SHEET TITLE
SITE PLANS
PROJECT ADDRESS
98 CUTLER ROAD,
CLONTARF

CLIENT
BOWES HOUSE
DOCUMENTATION
-

Drawn	Scale	Sheet	Date	Job N°.	Sheet N°	Issue/Revision
Author	1 : 200	A 3	14.8.19	0155-19	01-S4.55

01 - Level 1

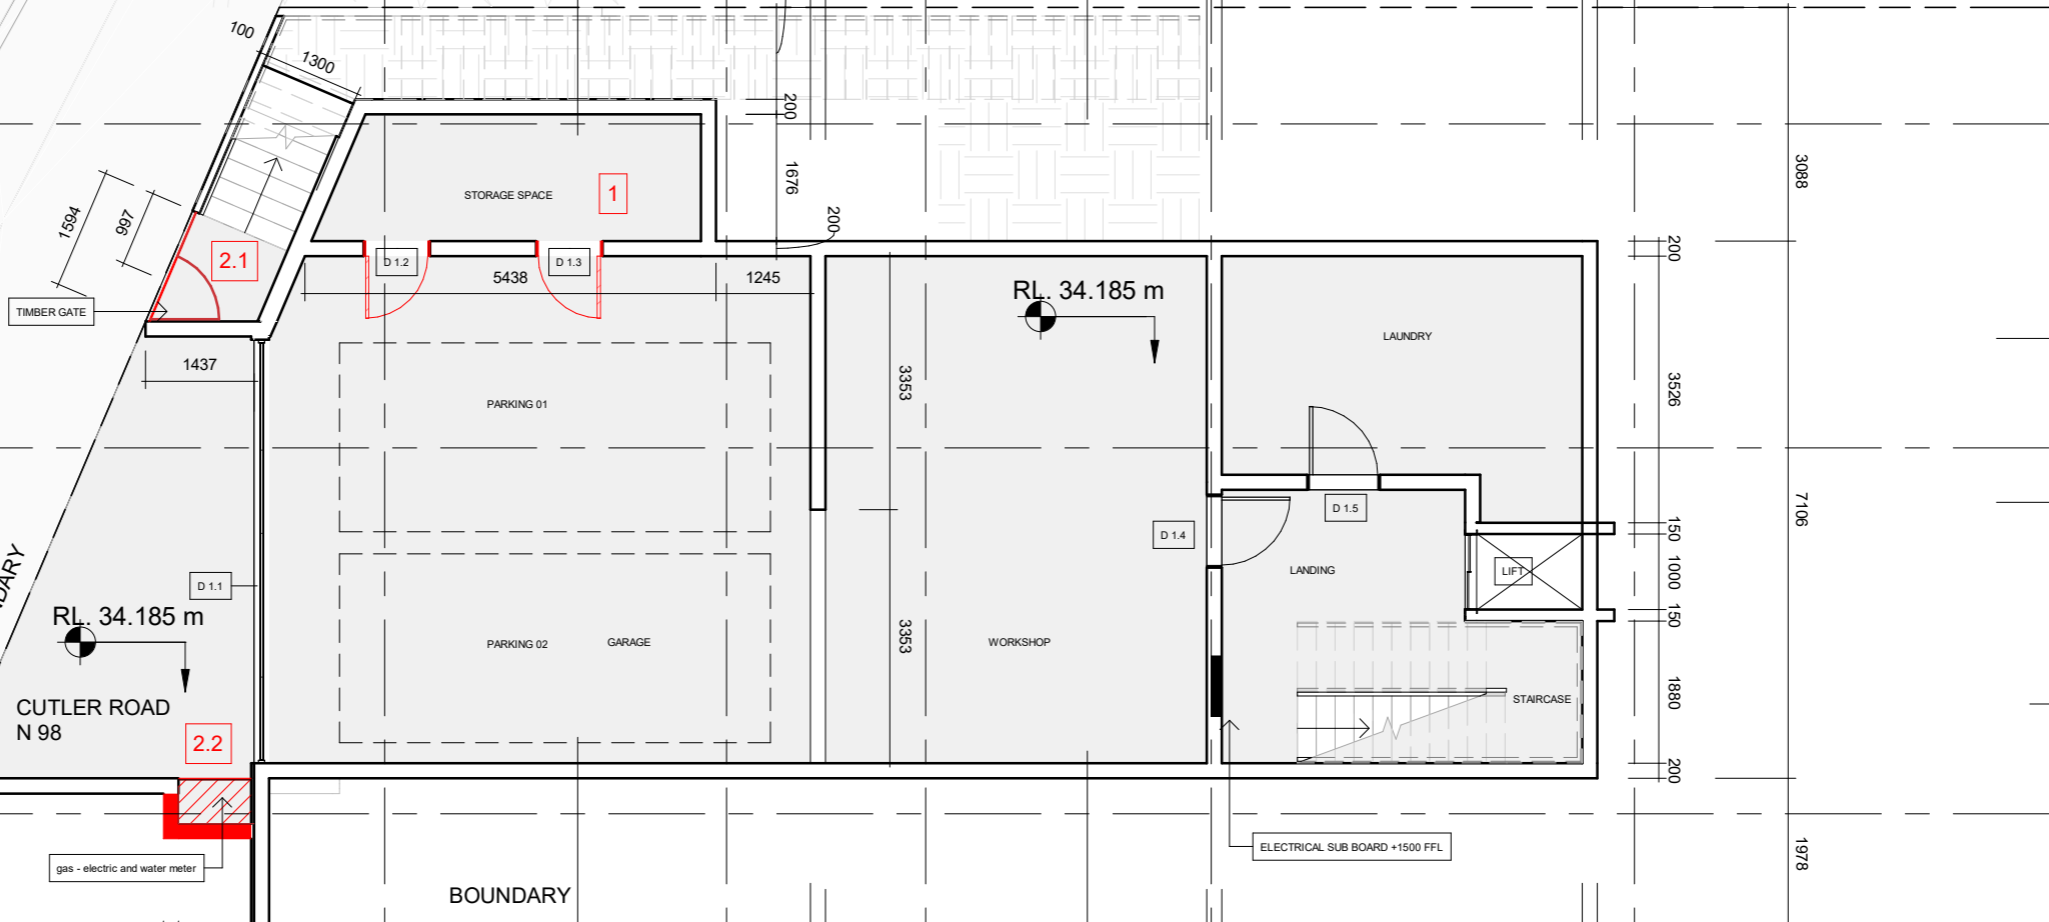
1. PROPOSED STORAGE SPACE
 2.1 Proposed front boundary security gate
 2.2 Gas - Electric and water meter
